Oil Mill Creek Design – New Options

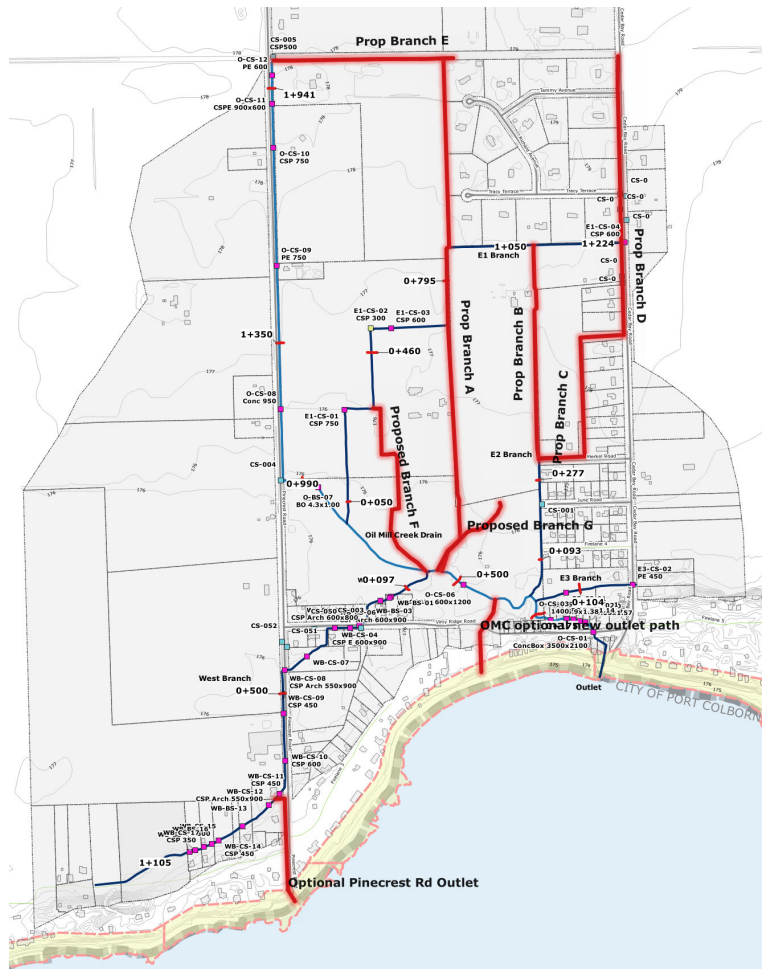
1. Overflow Outlet south through existing park.
2. New Outlet through Pinecrest Rd.

1. Option A – yes improved
2. Option B – works but min benefit
3. Option C – local improvement
4. Option D – existing path better
5. Option E – Existing works
6. Option F – No benefit
7. Option G – existing path
